**CORRESPONDENCE COVER SHEET  
WASTE PERMITS DIVISION  
TEXAS COMMISSION ON ENVIRONMENTAL QUALITY**

Date: April 25, 2019  
 Facility Name: City of Kingsville Landfill  
 Permit or Registration No.: MSW 235-C

Re: City of Kingsville Landfill – Kleberg County  
Municipal Solid Waste (MSW) - Permit No. 235C  
Permit Amendment Application – Notice of Deficiency  
Tracking No. 23301130, 23458984, and 24040819; RN102334570/CN600674246

On behalf of the City of Kingsville and in response to the Texas Commission on Environmental Quality's (TCEQ) March 27, 2019 Notice of Deficiency (NOD) letter, we hereby submit the enclosed response regarding the Permit Amendment Application for the above referenced MSW facility.

FIGURE:  
 III.2-1

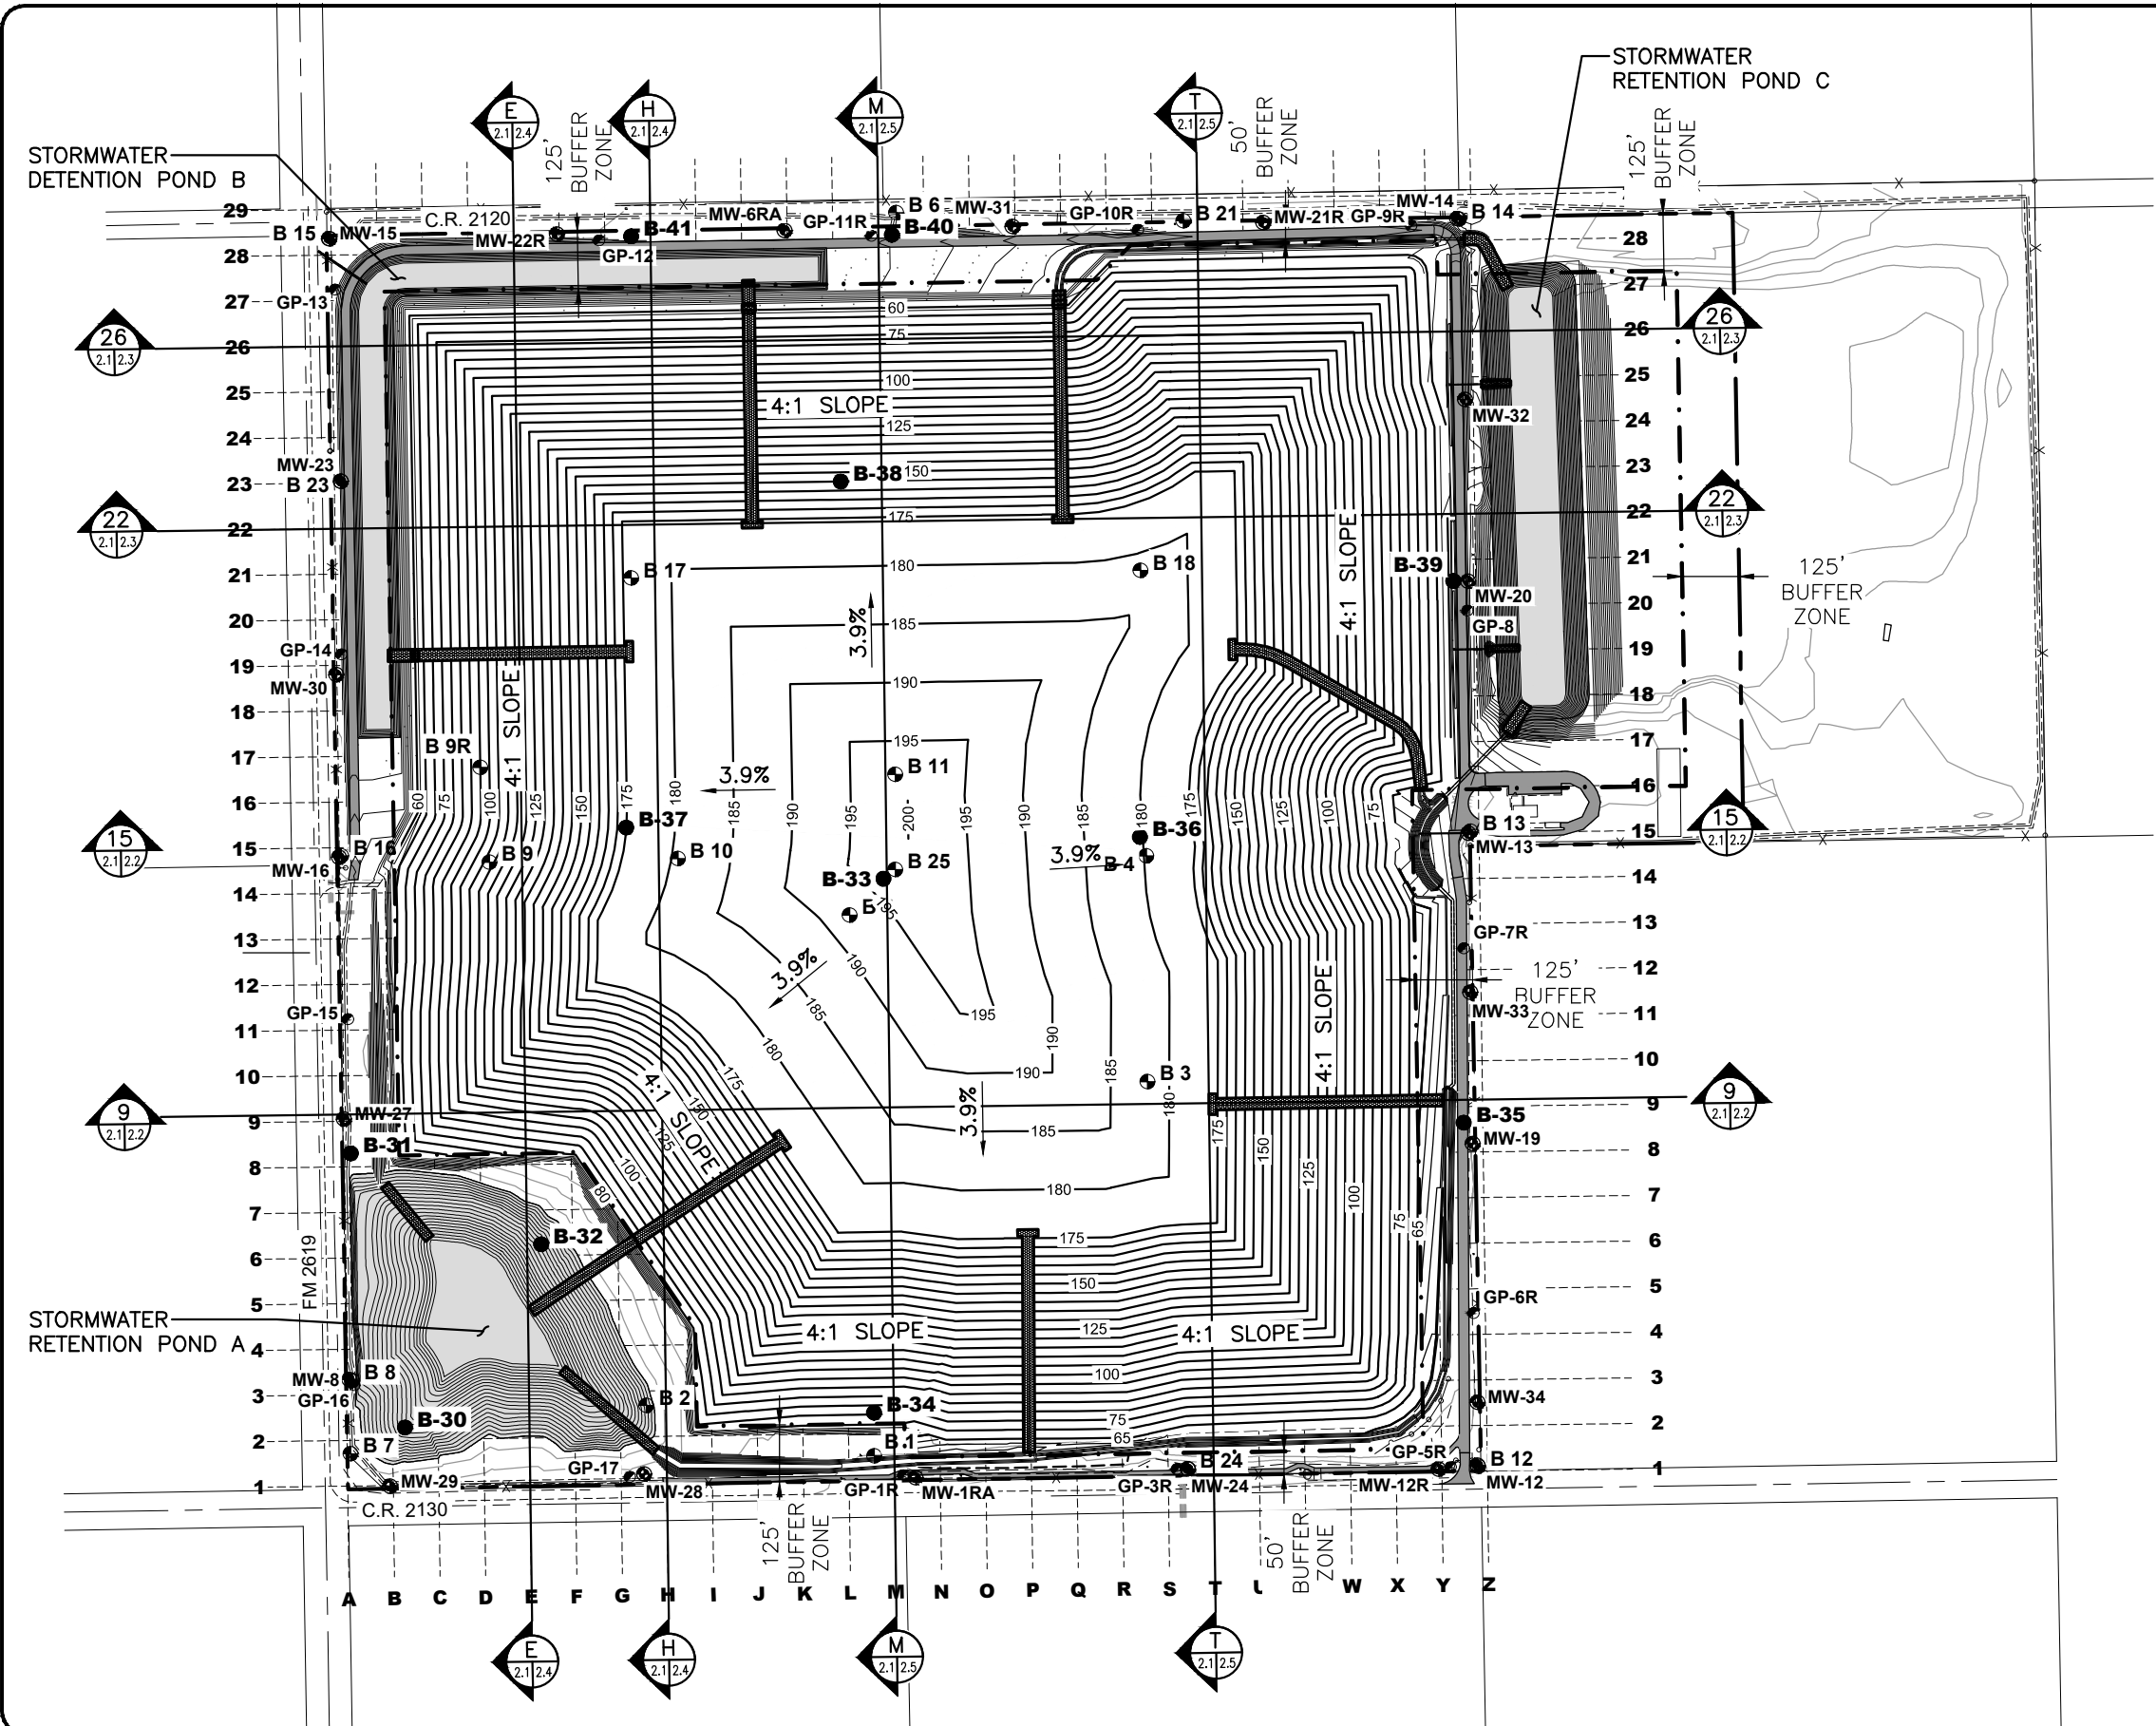
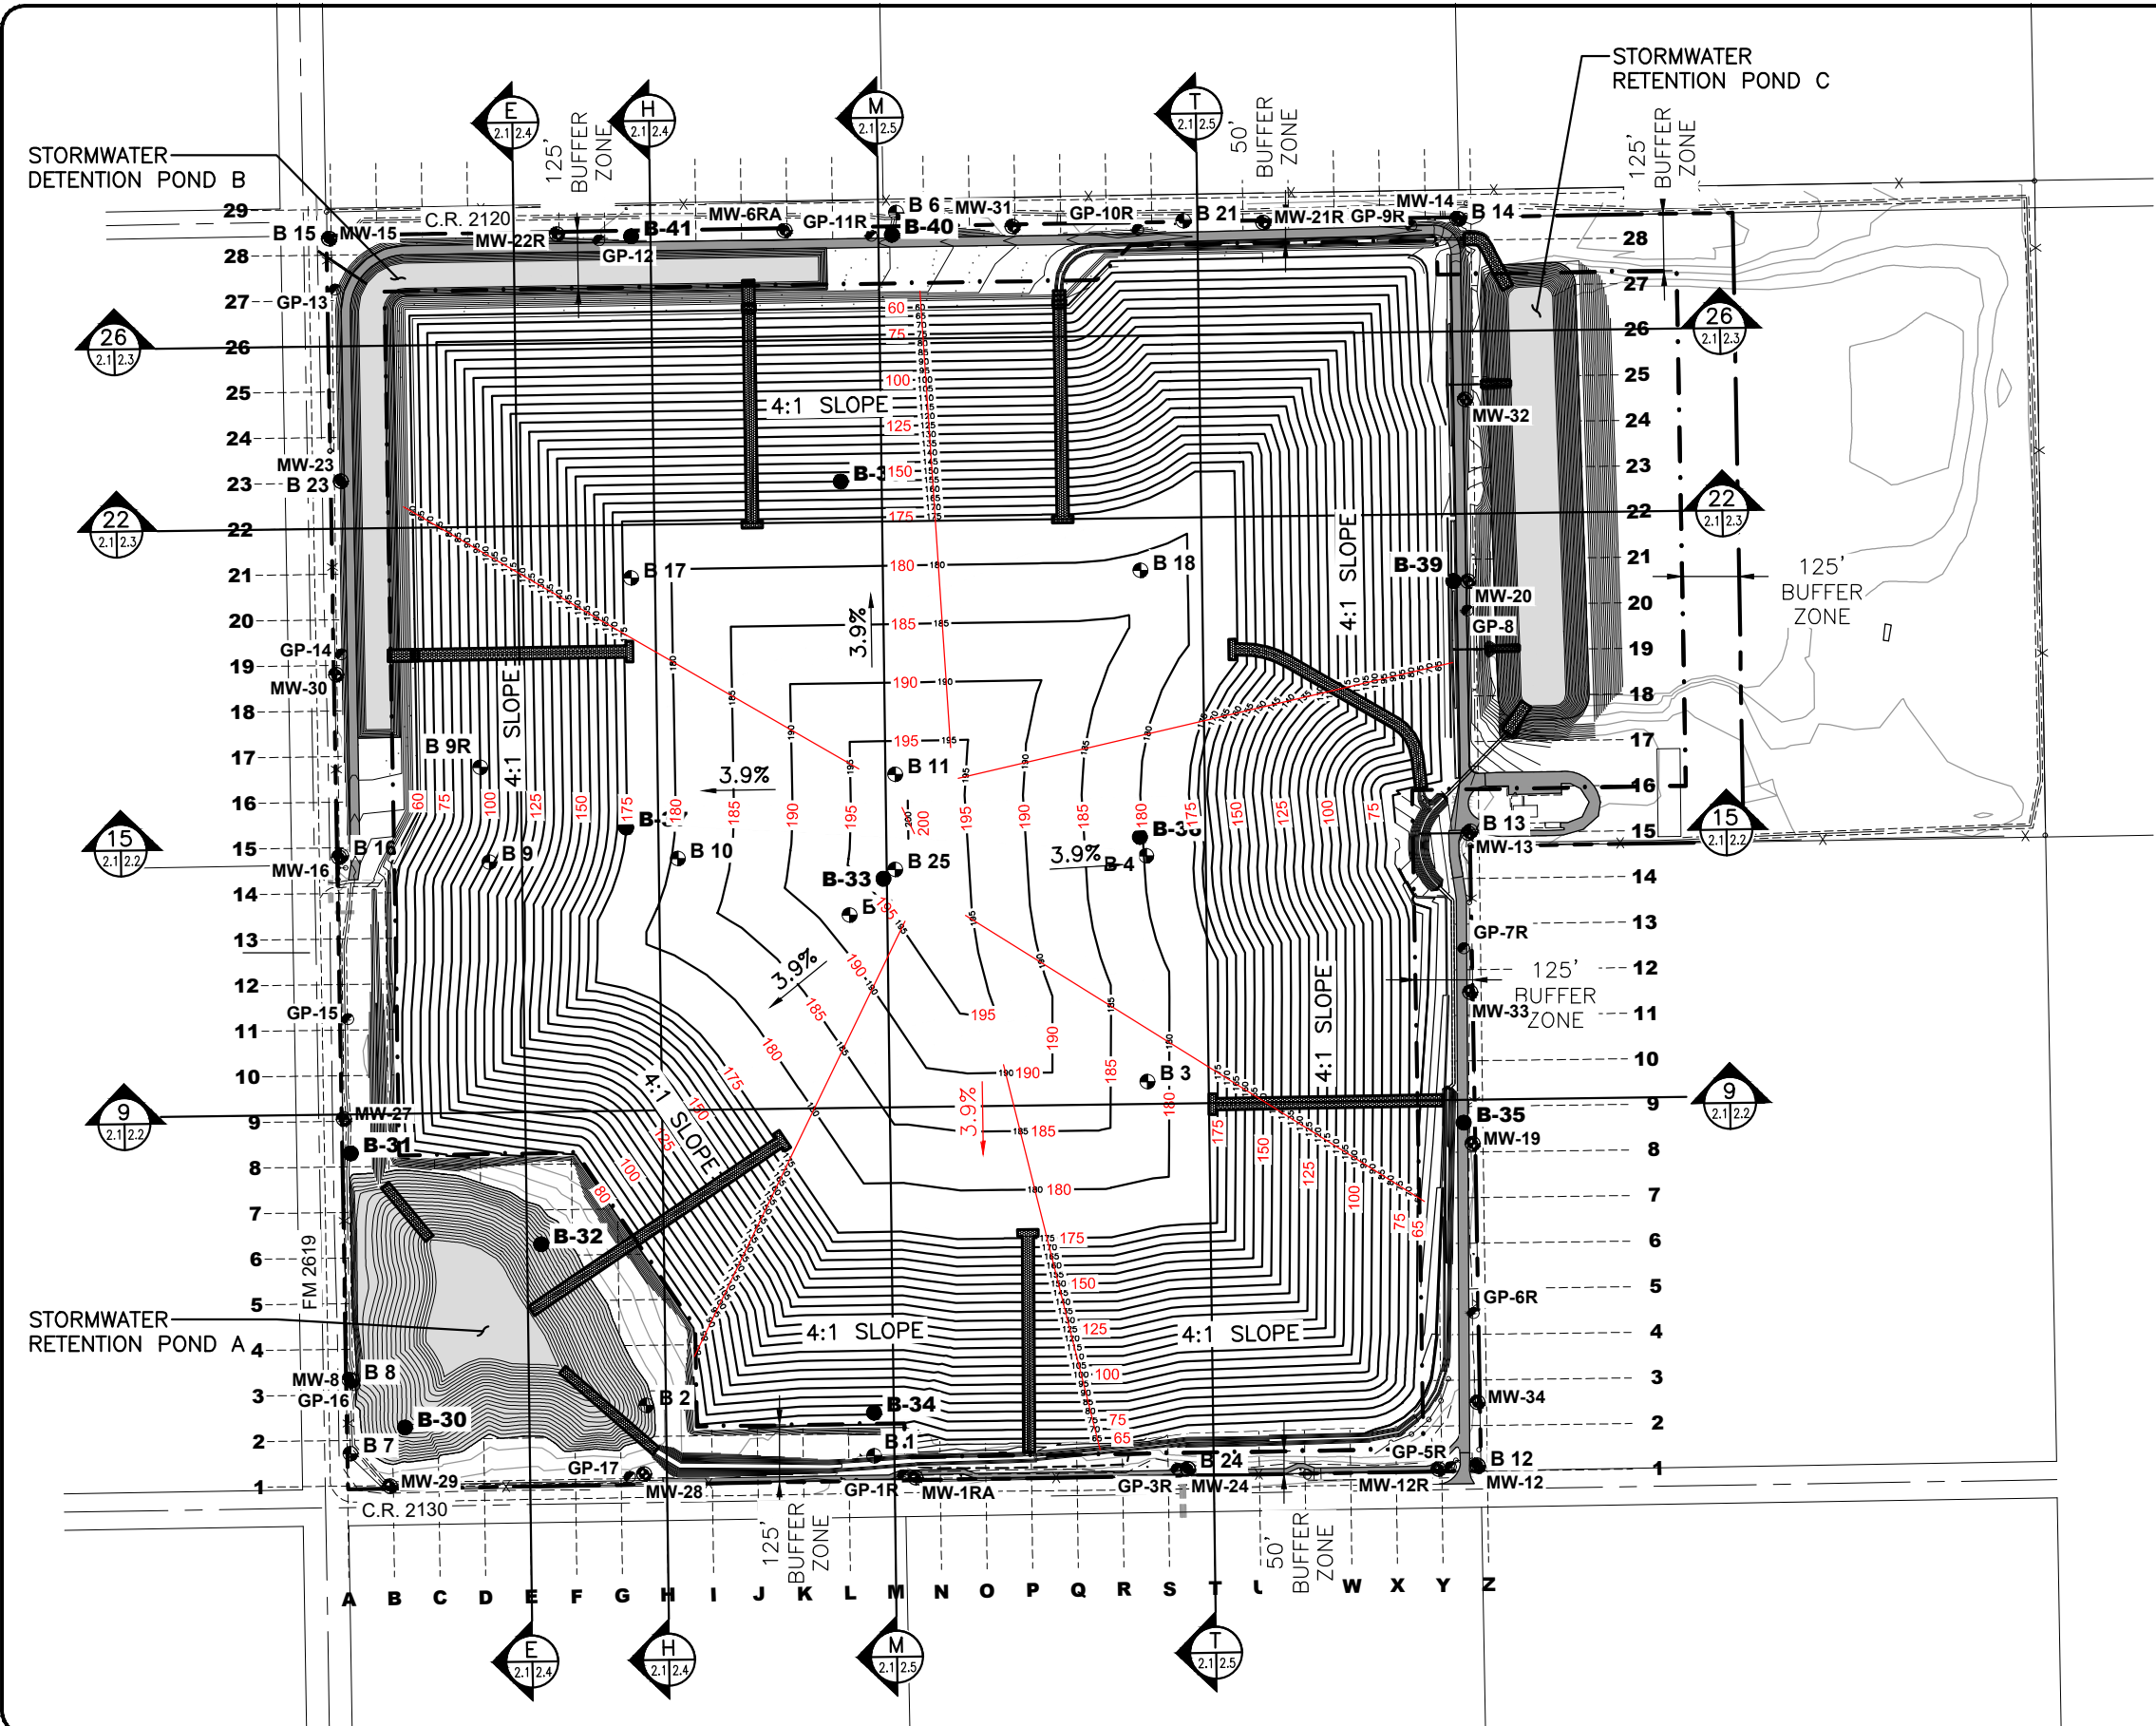
T10	353	Part III	330.63(d)(4)(E)	Vol 1, Att 2, Fig III.2-1 thru III.2-5	Ambiguous	Revise Figure III.2-1 to clearly indicate landfill's maximum waste elevation, maximum final cover elevation, and elevation of the deepest excavation.	Figure III.2-1 has been revised to enlarge the contour labels to make them more legible, and a note has been added to clearly indicate the landfill's maximum waste elevation, maximum final cover elevation, and elevation of the deepest excavation.
T11	356	Part III	330.63(d)(4)(E)	Vol 1, Att 2, Fig III.2-1 thru III.2-5	Ambiguous	Clarify the meaning of each line and revise each section on Figure III.2-2 to Figure III.2-5 to show the top of the waste (existing fill), existing ground, bottom of the excavation. Revise the meaning of dotted line for active sectors on Figure III.2-3, Marker 26 Section, and Figure III.2-5, Marker T Section.	Figures III.2-2 to Figure III.2-5 have been revised to clarify the lines representing final grade, top of waste, existing grade, subgrade, and piggyback liner. Revisions to line callouts have been made and additional callouts have been added to provide additional clarification.
